Ministry
of Defence

ACP-2020-24

E-7 WEDGETAIL OPERATING AREAS

**STEP 2A AIRSPACE CHANGE DESIGN OPTIONS
AND
DESIGN PRINCIPLE EVALUATION**

Figure 7. B1-B4 Outer Hebrides

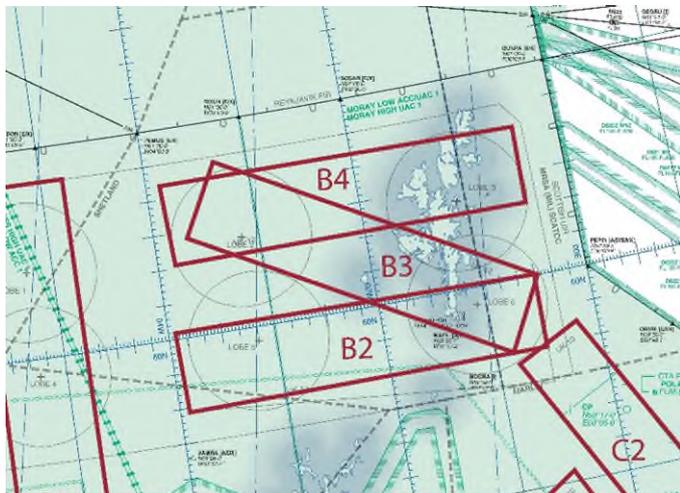
Limited impact on high level air routes and FRA

Coord with Swanwick Mil regarding concurrent activation with D712.

Figure 8. C1-C2 Moray Firth

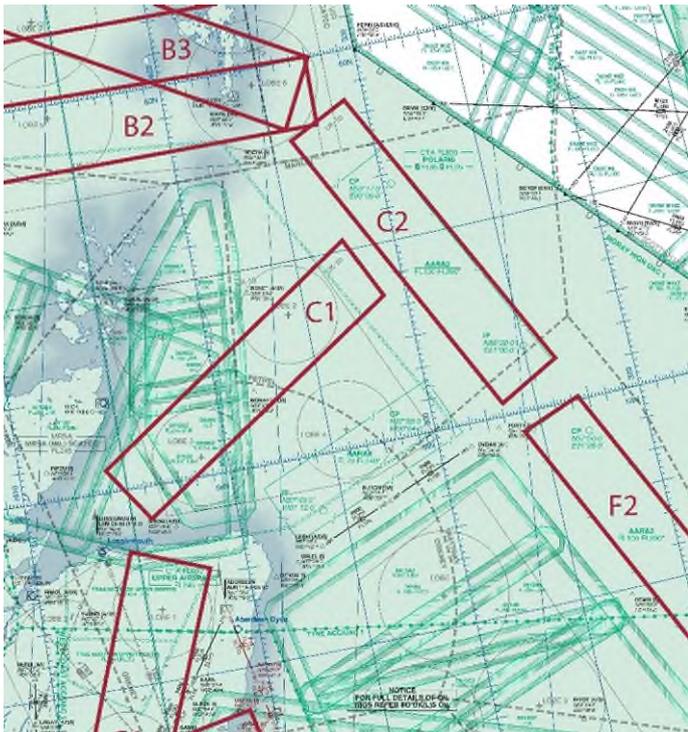
C2 new area to E of UK 10. Overlap with AARA2 (FL100-290) – coordination via Swanwick Mil or pre-flight planning.

Limited impact on high level air routes and FRA.

Figure 9. D1 and E1-E2 East Coast

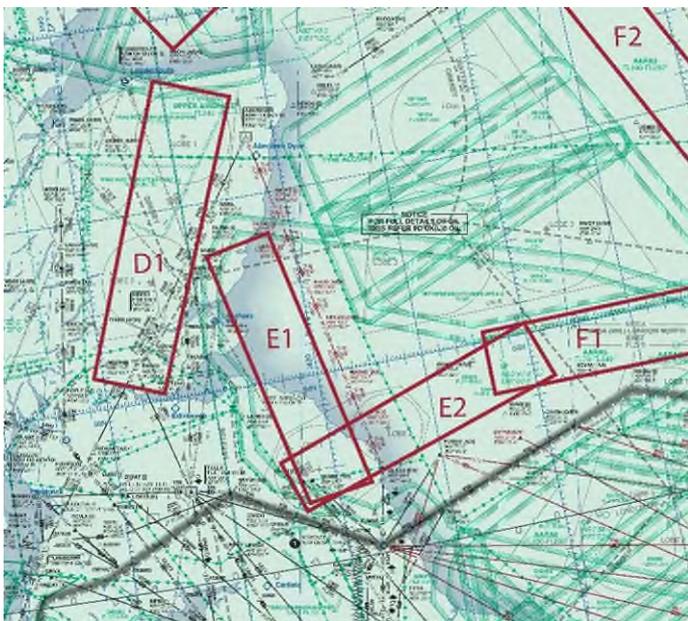
E1 IVO Edinburgh and Newcastle Aerodromes. No effect on SIDS/STARS due to altitude.

E2 IVO Newcastle Aerodrome only. No effect on SIDS/STARS due to altitude. Located above AARA5 (FL070-240) and between D323 and D613 series danger areas, coordination will be managed through Swanwick Mil/ASACS.

Area 10

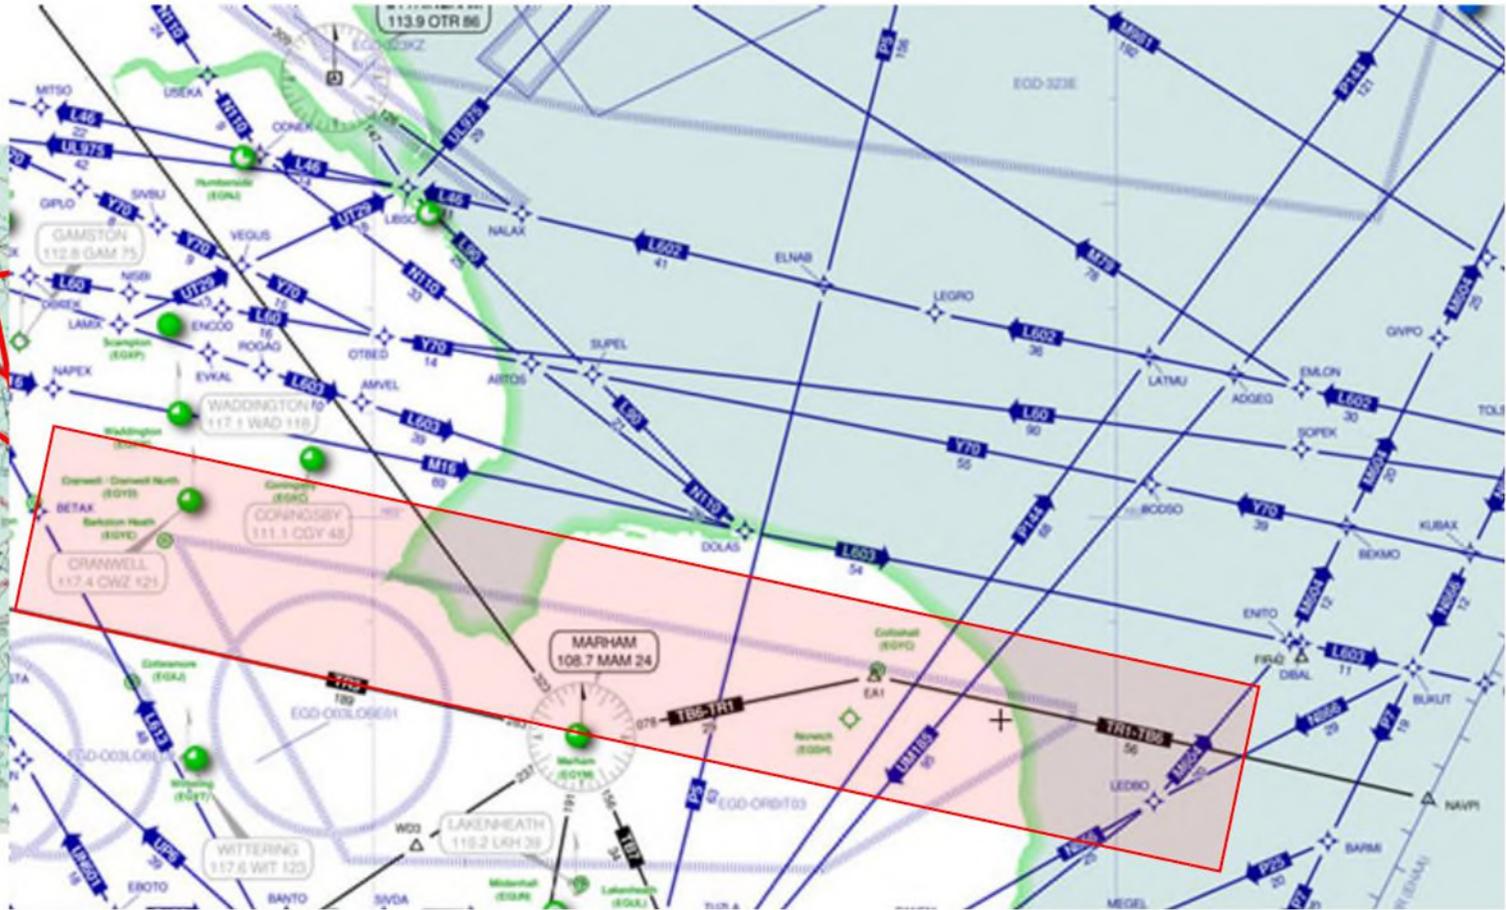
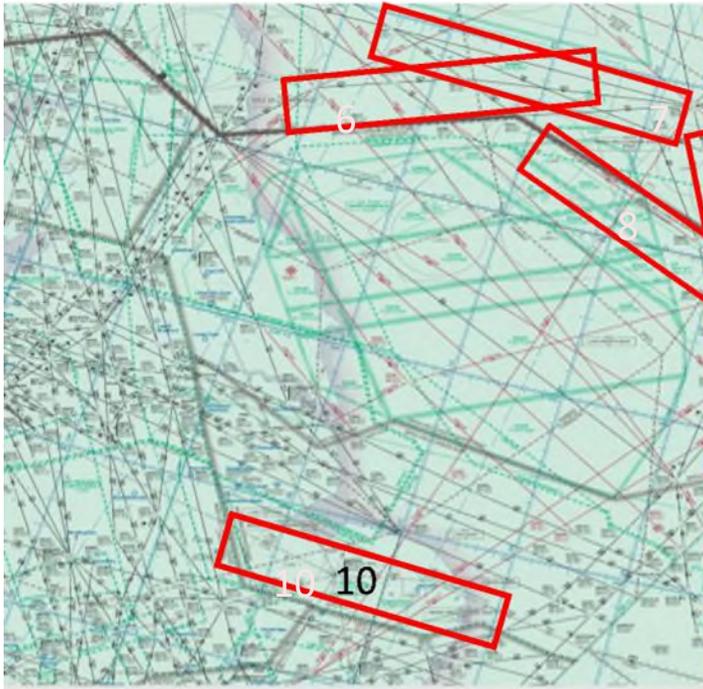
Map resolution is difficult to assess with confidence – Assumptions below on impacts

Difficult to determine exact proposed location due to map resolution, have added map to try and assess the area. However, some approximate co-ordinates and or a high resolution map would assist a full impact assessment.

The response is assuming the worst case of location-

A 100 x 20m rectangle in the middle of our airspace at other levels would cause a lot of problems as it wouldn't leave enough room to go round to the north without entering the NWMTA and going south of it would either end up with traffic in S9's airspace and having to avoid the danger areas along the coast of Wales.

If it has to be there, then the only acceptable level would be FL270 as it would allow us to get the majority of the LTMA and EIDW traffic above it and equally EIDW inbounds descending on top of it.

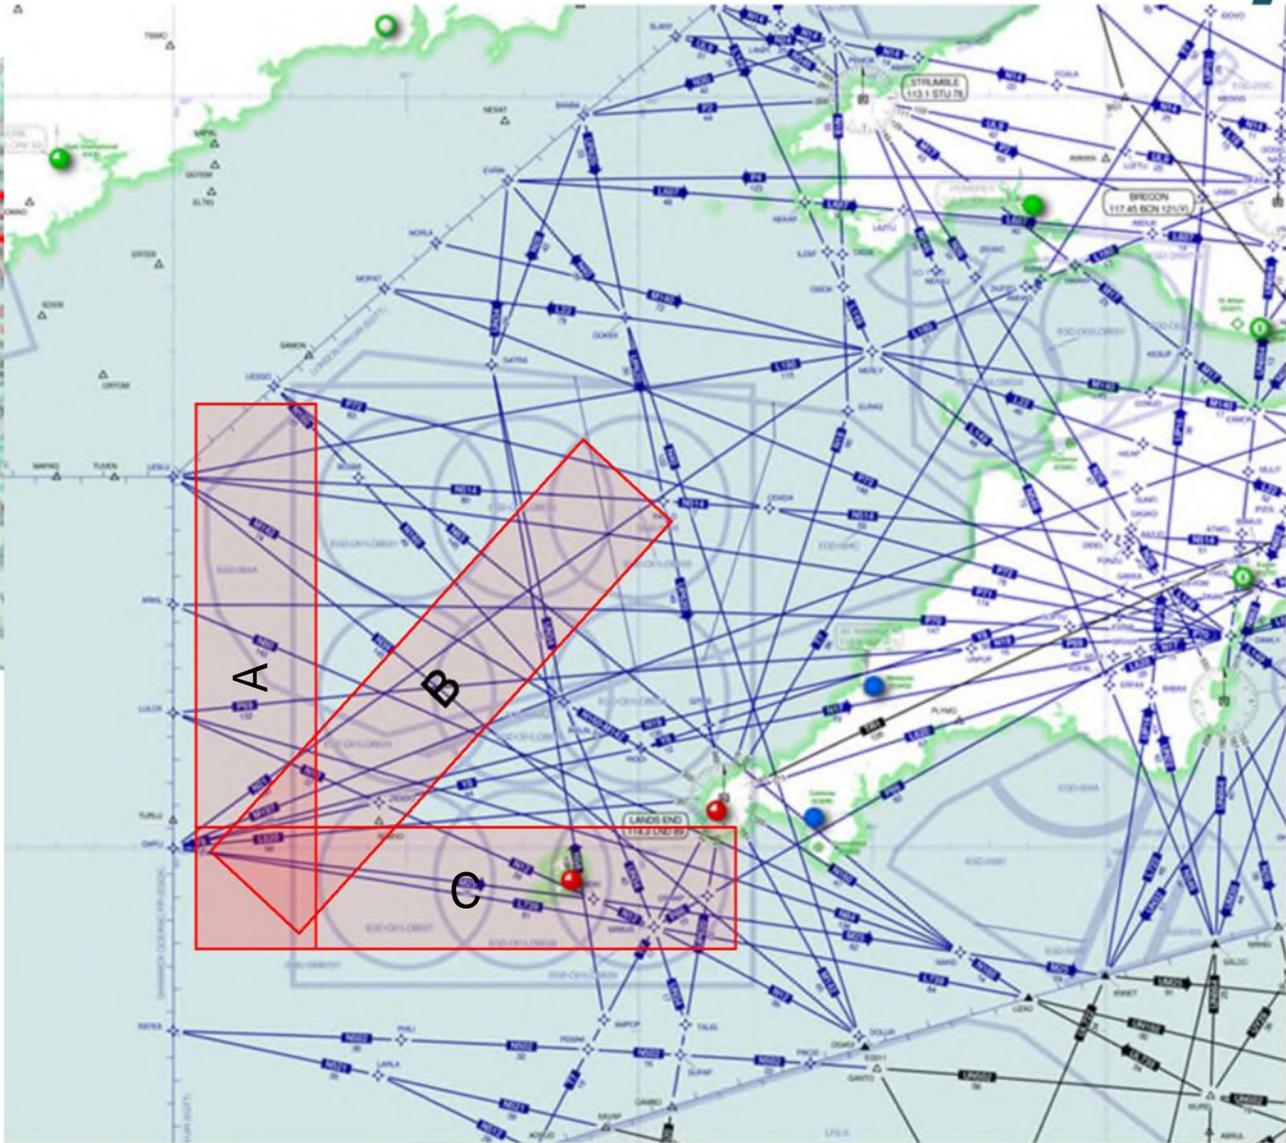
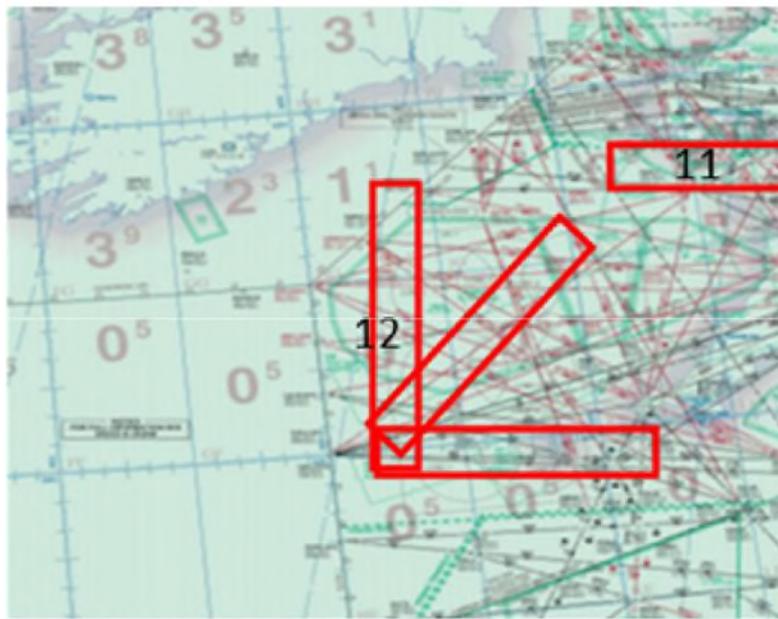
- *It would impact the following major flows*
 - ***LTMA inbounds and outbounds -***
 - ***EIDW inbounds and outbounds***
 - ***Manchester TMA traffic, at eastern extremity of the Area, on the North south ATS route structure. Ideally, it needs to be somewhere else where it's not going to cause an unmanageable workload when the traffic returns.***
